RE: Preliminary Plan No. 120180250
Primrose at Layhill

RE: Preliminary Plan No. 120180250
Primrose at Layhill
AMENDED LETTER

Re: **COMBINED STORMWATER MANAGEMENT
CONCEPT/SITE DEVELOPMENT
STORMWATER MANAGEMENT PLAN** for
Primrose Layhill
Preliminary Plan #: 120180250
SM File #: 282828
Tract Size/Zone: 3.61/R-200
Total Concept Area: 3.61ac
Lots/Block: N/A
Parcel(s): A
Watershed: Northwest Branch

Re: Stormwater Management **CONCEPT**
RECONFIRMATION for Primrose Layhill
SWM Concept #:282828

PRELIMINARY PLAN			
SCALE AS SHOWN	DATE 12/02/18	DRAWN BY LFZ	CHECKED BY EJI
PROJECT NUMBER 16001174A		DRAWING NAME C-SIGHT-DIST	
SHEET TITLE SIGHT DISTANCE EXHIBIT			
SHEET NUMBER 1 of 1

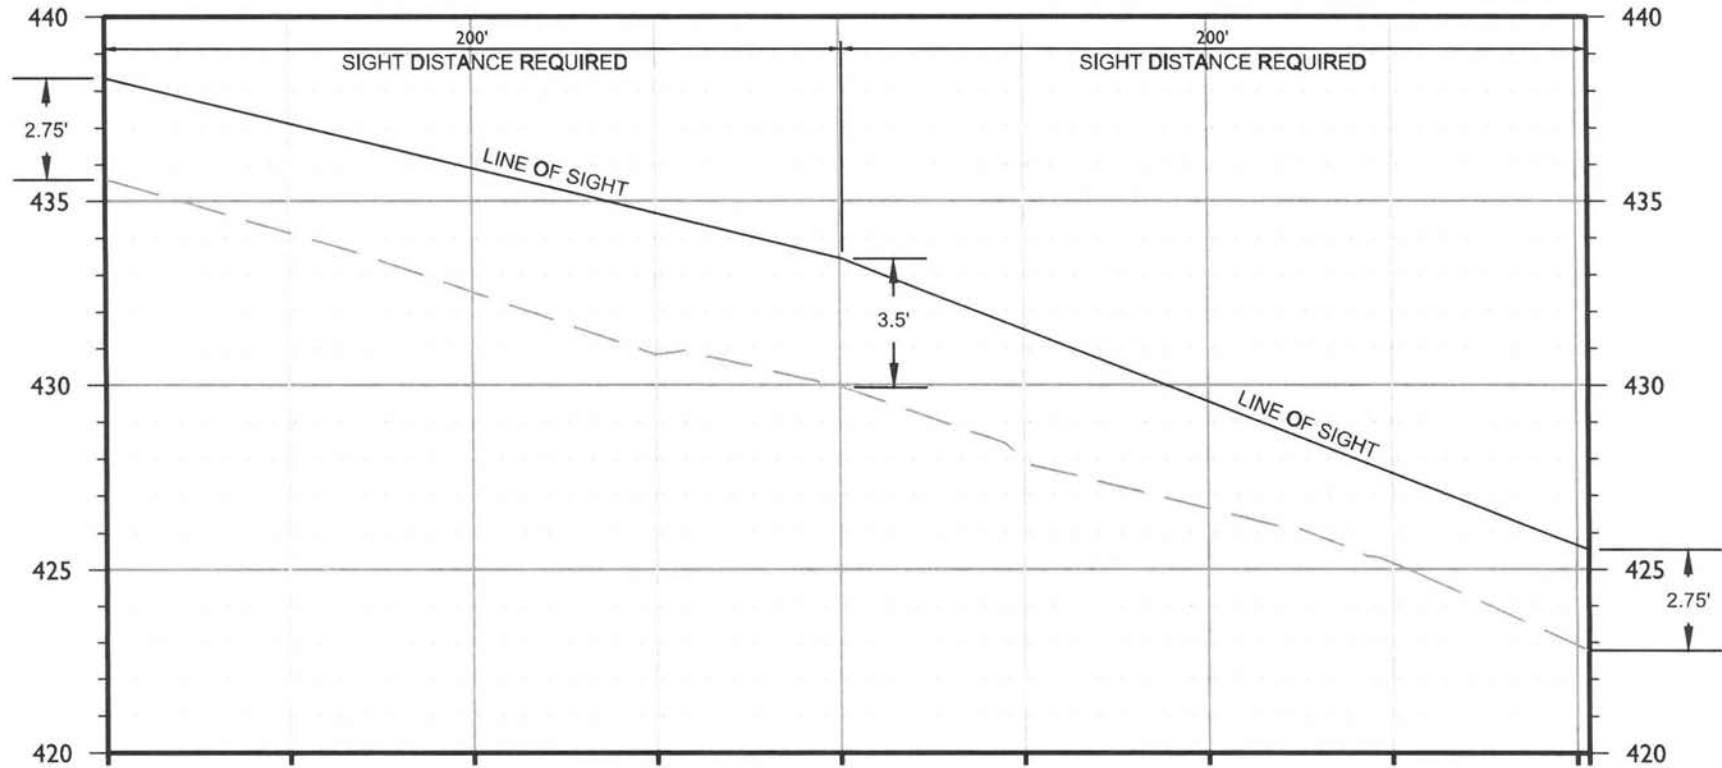
Sight Distance (feet) OK?
 Right 785 Yes
 Left 200 Yes

Montgomery County Review:	
<input checked="" type="checkbox"/>	Approved
<input type="checkbox"/>	Disapproved:
By:	<u>[Signature]</u>
Date:	<u>01/03/19</u>
